January 24, 2022

SCO ID# 20-21659-01A
REPAIRS TO NCDOT EDGEcombe COUNTY
EQUIPMENT & LUBE SHOPS

ADDENDUM No. 2

1 EQUIPMENT SHOP ROOF PLAN
SCALE: 1/8" = 1'-0"

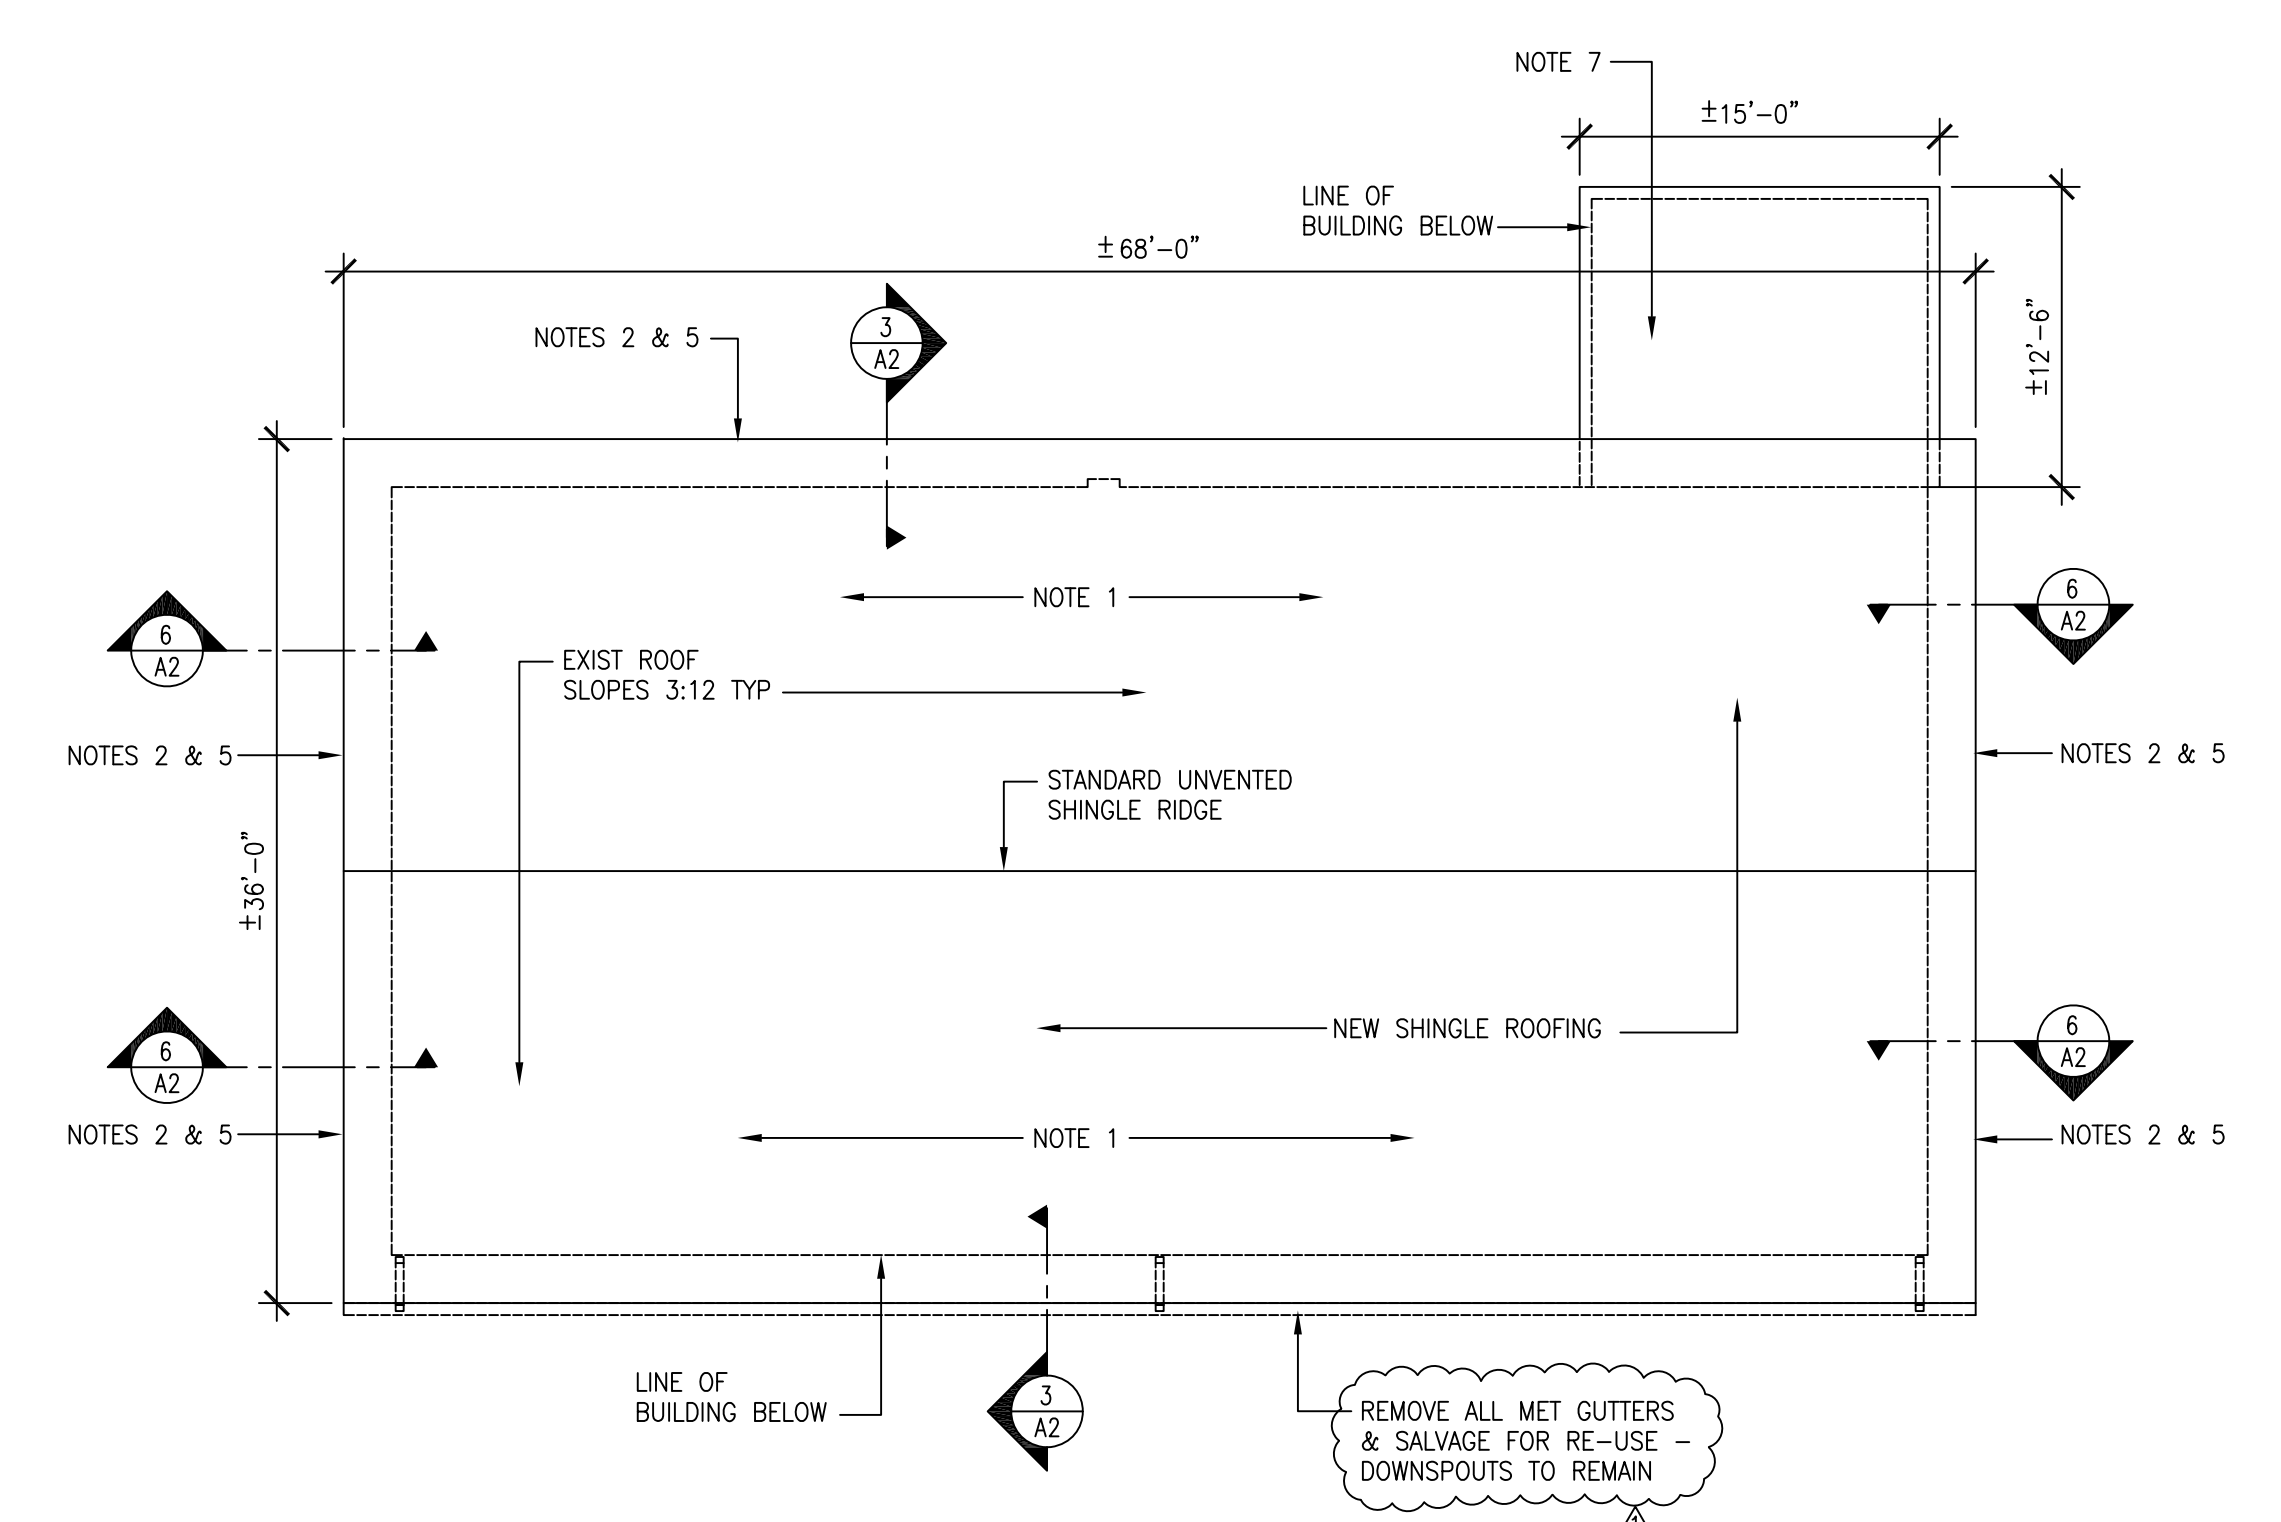
Item No. 3	Drawing A2	Refer to Equipment Shop Roof Plan 1/A2 and Roof Replacement Note No. 8. Demolish plywood soffit panels where indicated and replace with PVC panels to match. Owner will paint to match adjacent,

Item No. 4	Drawing A2	Refer to Lube Building Roof Plan 2/A2. The requirement for new gutter and downspouts has been deleted.
Item No. 5	Drawing A2	Refer to Detail 6/A2. Owner will remove all devices attached to existing raking cornices. See Attachment 'B'.

8. REPLACE PLYWOOD SOFFIT PANEL WITH PVC PANEL TO MATCH. RE-INSTALL SOFFIT VENT TO ORIGINAL POSITION.
